Groundwater Transfer Review Summary Form

Transfer/PA # T- <u>13966</u>
GW Reviewer <u>Joe Kemper</u> Date Review Completed: <u>8/23/2022</u>
Summary of Same Source Review:
The proposed change in point of appropriation is not within the same aquifer as per OAR 690-380-2110(2).
Summary of Injury Review:
\Box The proposed transfer will result in another, existing water right not receiving previously available water to which it is legally entitled or result in significant interference with a surface water source as per 690-380-0100(3).
Summary of GW-SW Transfer Similarity Review:
☐ The proposed SW-GW transfer doesn't meet the definition of "similarly" as per OAR 690-380-2130.
This is only a summary. Documentation is attached and should be read thoroughly to understand the basis for determinations.

Oregon Water Resources Department 725 Summer Street NE, Suite A

Map of Proposed POA Changes

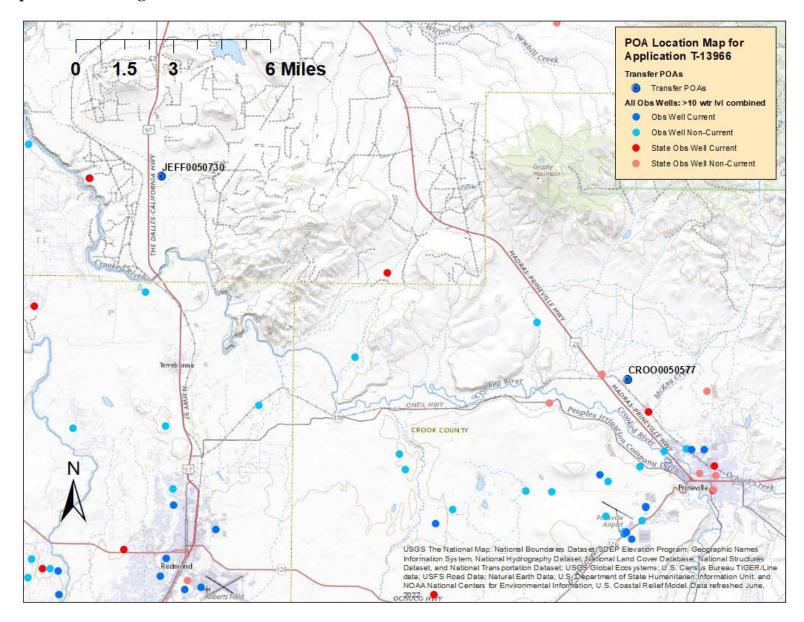
* *				or proposed to be developed.
Other				
0.5 cfs from	CROO 50577 unde	er certificate 9	6129 to JEFF 5073	applicant proposes to move 30. The applicant also adustrial/manufacturing to
Yes Solution Yes	No Comments ces water from Quavels that directly of the comments lluvial aquifer app Deschutes Format within a package of the comments Output Deschutes F	The two well aternary aged overlie the Joh ears to be largion. JEFF 507 of volcanics (pgic units, aquit	s are located more (and potentially la n Day Formation (sely separate from (30 produces water resumably the Desfers, and have separate from (and produces)	e existing authorized POA? e than 15 miles apart. CROO te Tertiary) unconsolidated (Ferns and McClaughry, the regional aquifer system from a coarse alluvial schutes Formation). These harate recharge-discharge ume source.

4.	a) Will this proposed change, at its maximum allowed rate of use, likely result in an increase in interference with another ground water right ?
	⊠ Yes ☐ No Comments: There are several adjacent tax lots that are presumed to have
	domestic water supply wells within 2000-2500 feet from JEFF 50730. The proposed transfer
	will likely result some in well-to-well interference with those wells.

b) If yes, would this proposed change, at its maximum allowed rate of use, likely result in another groundwater right not receiving the water to which it is legally entitled? Yes No If yes, explain: The expected well-to-well interference is unlikely to
	Yes No If yes, explain: <u>The expected well-to-well interference is unlikely to</u> reach a magnitude that would be considered injury.

5.	a) Will this proposed change, at its maximum allowed rate of use, likely result in an increase in interference with another surface water source ? Yes No Comments: CROO 50577 is closer (~1 mile) to the Crooked River than JEFF 50730 (~2 miles). Stream depletion is expected to decrease from the proposed change.
